ADDENDUM ONE

Purdue University, Fort Wayne, Indiana
Helmke Library Basement Drainage Renovation - 2025

Commission No.: F24054

Addendum Date: March 12, 2025

General Construction Notes

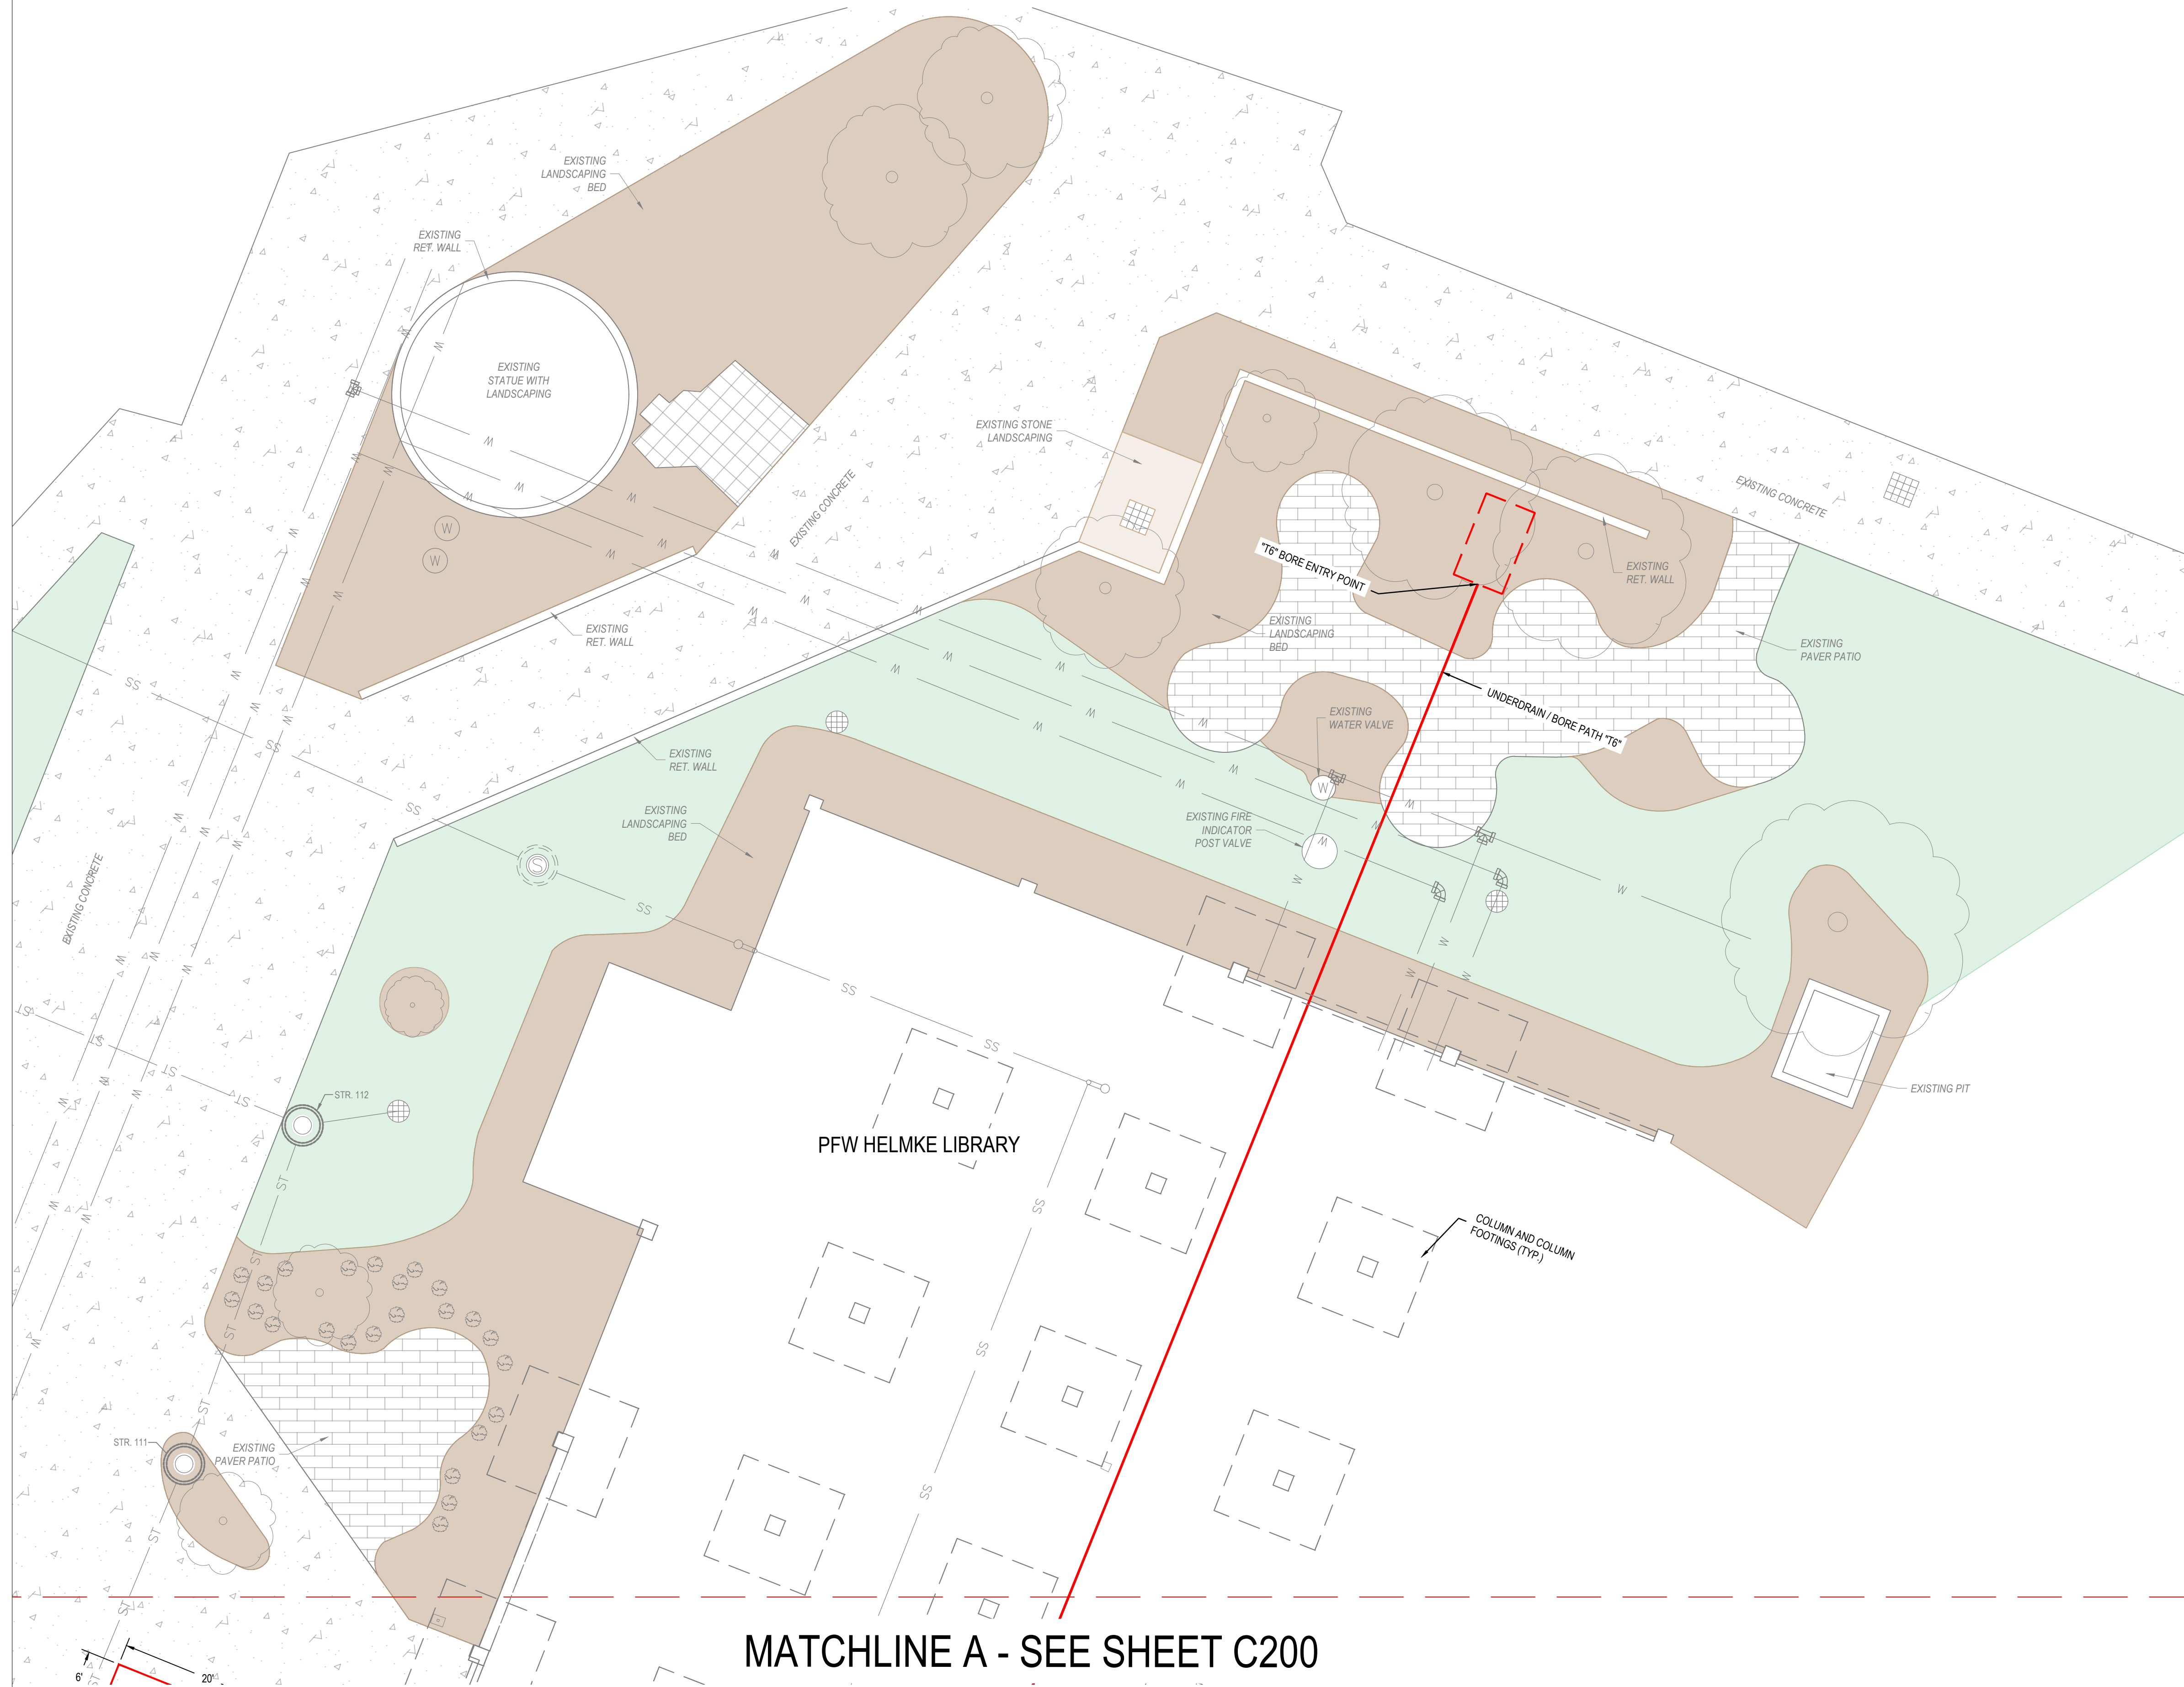
REPLACE Sheet C200 Site Layout Plan with new C200
Revisions include:

Added General Construction Note 10 “Contractor to furnish Ground Penetrating Radar (GPR) prior to bore pit excavation and directional drilling in the bore pit excavation area

and along the first 50' (measured horizontally) of boring tuns from the of the start of bore pit.“

Depicted elevator shafts, columns and related footings.

Labeled 8” sanitary trunk line that is depicted on profiles “T-1” and “T-3”.

10. CONTRACTOR TO FURNISH GROUND PENETRATING RADAR (GPR) PRIOR TO BORE PIT EXCAVATION AND DIRECTIONAL DURING WITHIN 50' (MEASURED HORIZONTALLY) OF THE START OF BORE PIT.

General Notes

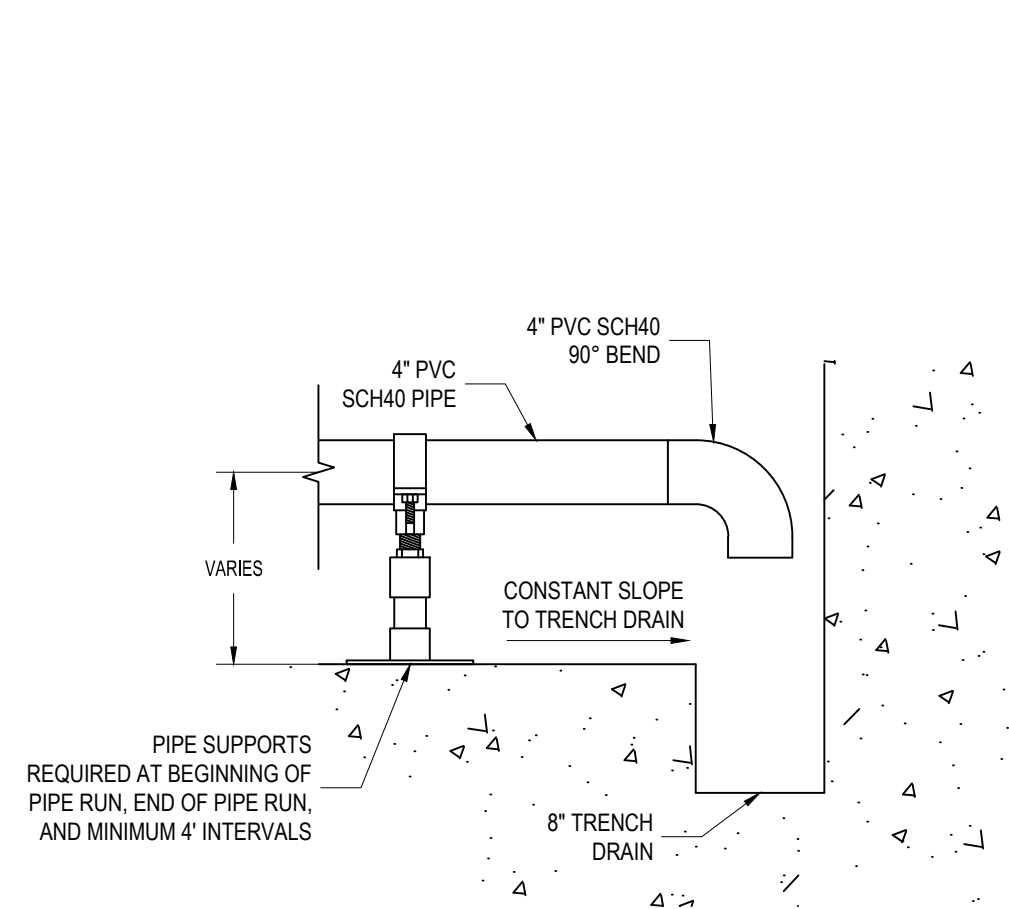
5. Contractor is responsible for providing, install, and maintain temporary chain-link fencing around any bore pits.
6. Scope for Alternate 2 further identified on sheet C800.

Added General Notes for Alternate 2 scope of work.

- 1. ALTERNATE 2 SCOPE OF WORK
 - INSTALL 4" ACTUATED BALL VALVE PER EACH DRAIN LINE.
 - MIN IP66 RATING.
 - BACNET COMMUNICATION PROTOCOL OR MODBUS COMMUNICATION WITH MODBUS TO BACNET ADAPTER.
 - PROVIDE 1 CONTROL DEVICE CONFIGURED TO OPEN OR CLOSE VALVES. DEVICE TO HAVE DISPLAY TO SHOW VALVE STATUS.
 - ACTUATOR TO OPERATE ON 120 VAC POWER SOURCE.
 - CONTRACTOR TO PROVIDE CONDUIT AND APPROPRIATE WIRING FROM VALVE LOCATIONS IN TUNNEL TO A SURFACE MOUNTED JUNCTION BOX LOCATED ON BASEMENT WALL NEAR TUNNEL OPENING FOR RETURN AIR DUCT.
 - OWNER TO PROVIDE POWER TO JUNCTION BOX.

7 Typical Tunnel Floor Pipe Extension Detail
NTS

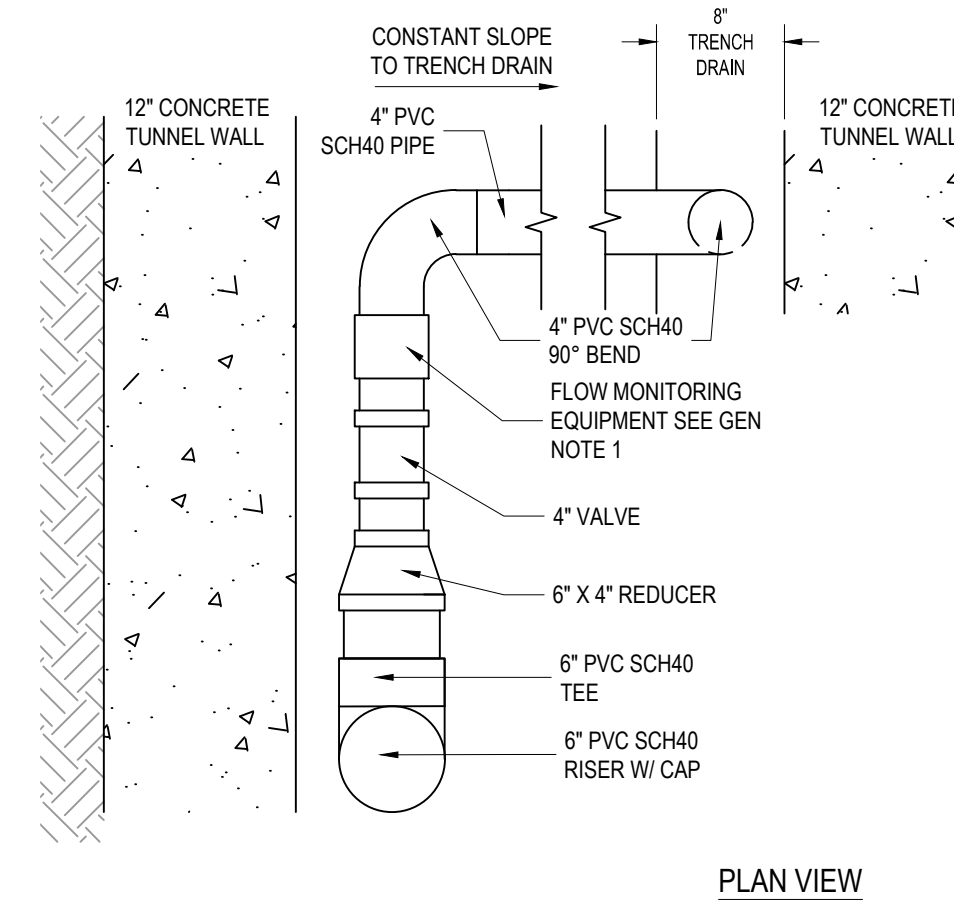
2. Bore materials may be stored on site. A staging area will be determined upon the award of contract.
3. The proposed drains entering the tunnel below the basement are to be sealed at the floor/wall, include a shut-off valve, and discharge piping to the existing trench drain. Additional details have been provided on sheet C800.

Added detail 7.

2 Tunnel Section View A
1" = 5"

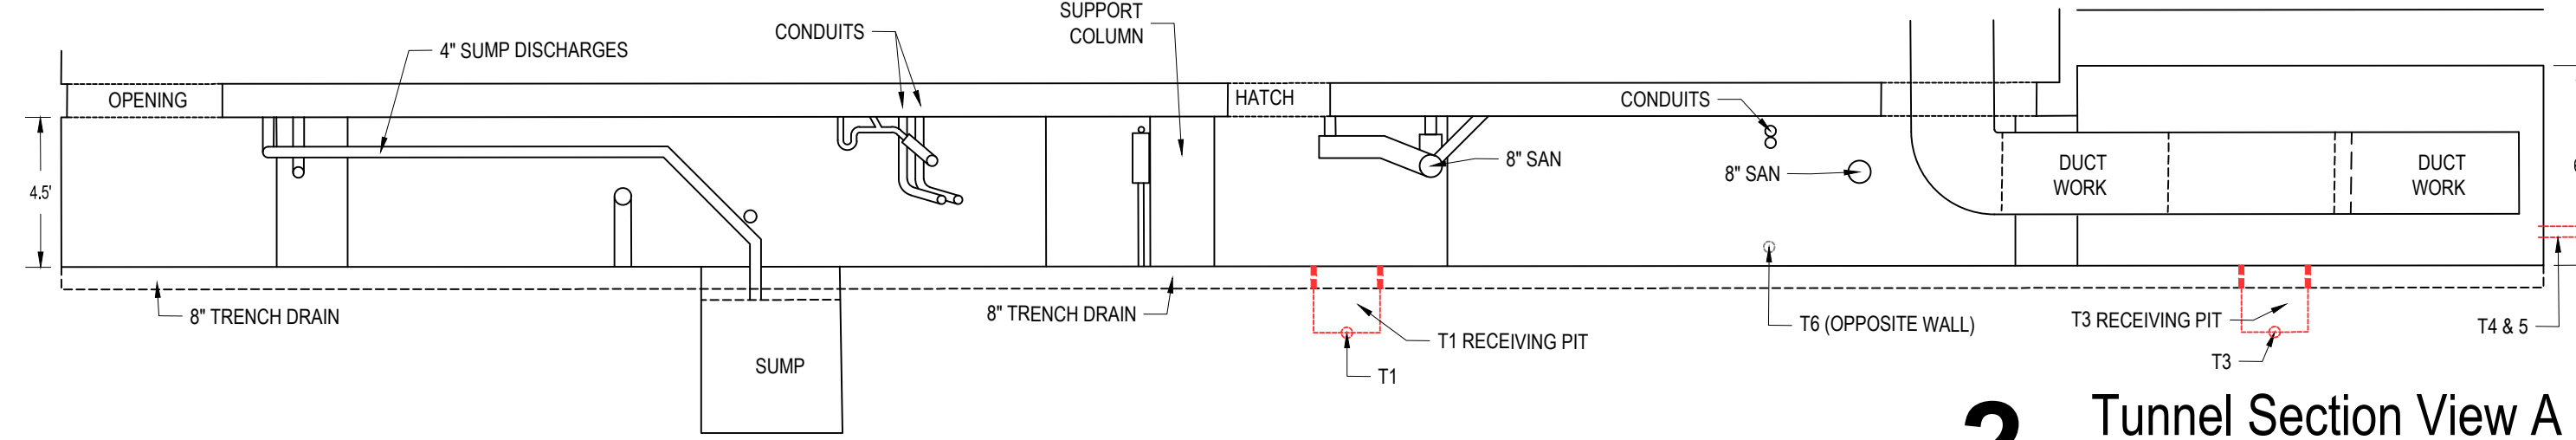
Sheet C801 Site Details

REPLACE NOTE on 2/C801 to read as follows:

“Contractor to temporarily support duct throughout project.

- Remove rivets/screws, clean sealant from Joints.
- Remove and save existing duct for reinstallation.
- Provide temporary ductwork connection to maintain a minimum return air flow throughout construction approximately equal to 50% of the installed duct.
- After completion of bore/pipe work, remove and legally dispose of temporary ductwork, reassemble original duct work, apply sealant, reinstall rivets/screws & remove temporary supports.”
